National Highways Planning Response (HEPR 16-01)

Formal Recommendation to an Application for Planning Permission

Council's Reference: LCC/2021/0007

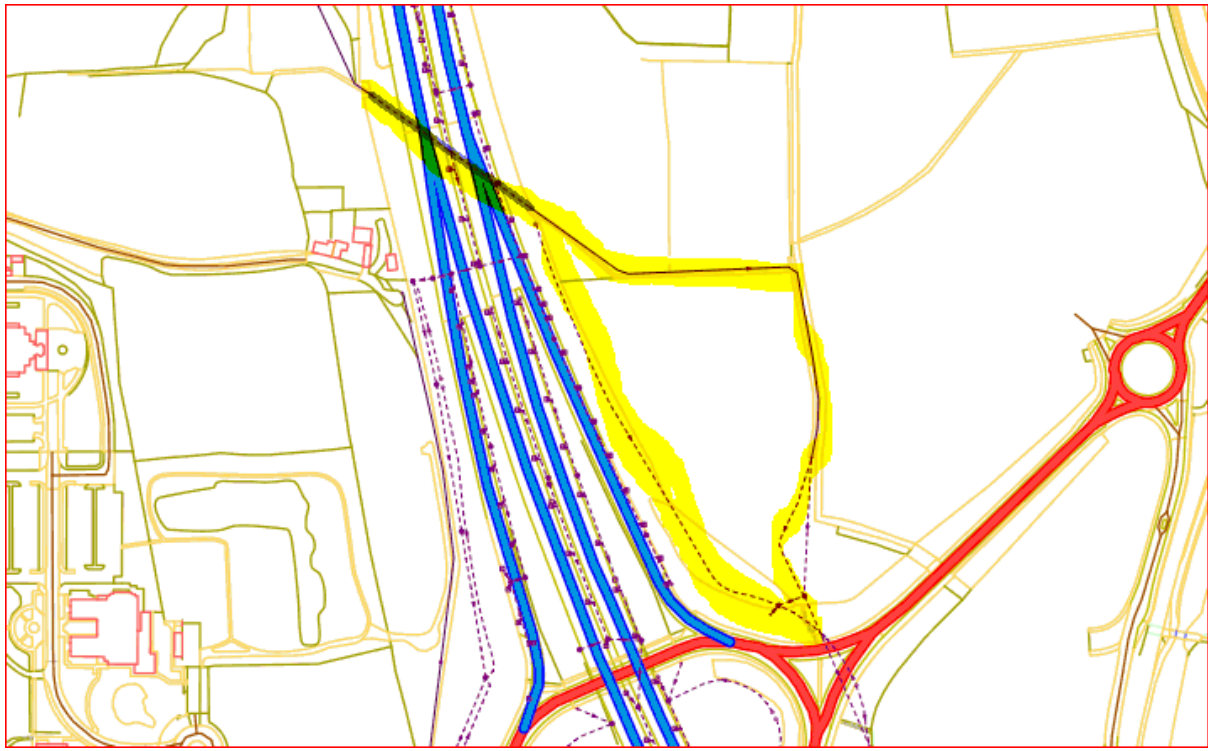
A motorway filter drain runs along the motorway boundary with this site at the foot of the motorway embankment., as shown in the drawing below. **Again, there will need to be a level of standoff agreed with National Highways from the excavation to ensure that this drain is not disturbed.**
